REMARKS/ARGUMENTS

AMENDMENT TO THE DRAWINGS

FIG. 4

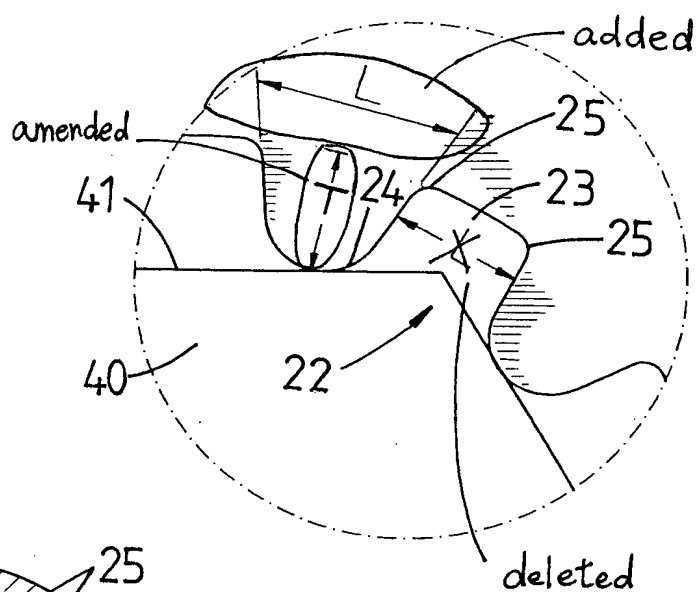
The Examiner stated that the specification and claims define "L" as the distance between the corner of each receiving recess and the corner of an adjacent receiving recess, but the drawings define "L" as the distance between the corners of a receiving recess. Consequently, it is not clear where the distance "L" lies. Additionally, since the corners of the receiving recesses are curved, it is not clear as to beginning and ending points of the distance "L". In addition, it is not clear how an increased depth "T" provides a larger contact area.

Replacement sheet of drawings are enclosed for the Examiner's approval. The attached sheet of drawings include changes to Fig. 4. This sheet, which includes Figs. 3 and 4, replaces the original sheet including Figs. 3 and 4. In figure 4, the position of the distance "L" has been corrected.

Responsive to this, figure 4 is corrected to match the specification and claims. In addition, figure 4 is also corrected to show beginning and ending points of the distance "L". In addition, the specification is amended in accordance with the Examiner's instruction to explain how an increased depth "T" (radius of curvature)
